SERVICE INFORMATION BULLETIN

APPLICABILITY: 2019-21MY Ascent

NUMBER: 12-316-21

SUBJECT: Rear Door Weatherstrip- Design Change

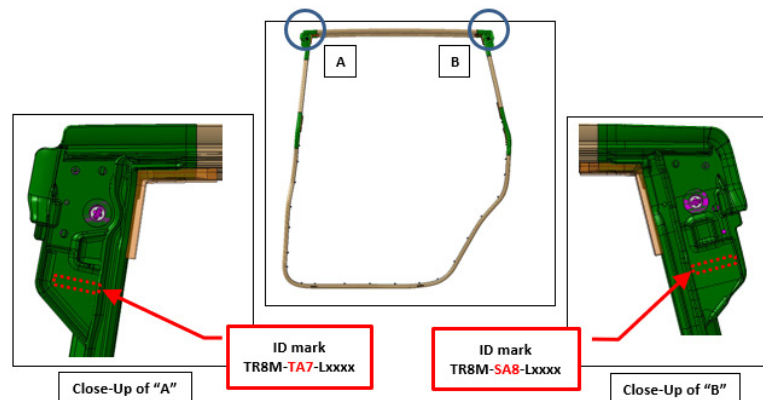
This Service Information Bulletin announces changes made to the rear door weatherstrip to optimize their water sealing performance.

Identifying The New Weatherstrips:

The new weatherstrips have identification markings near the upper corners as shown below:

Description	Part Number	Application
WEATHER STRIP-REAR DOOR	63512XC00D	RIGHT REAR
	63512XC01D	LEFT REAR
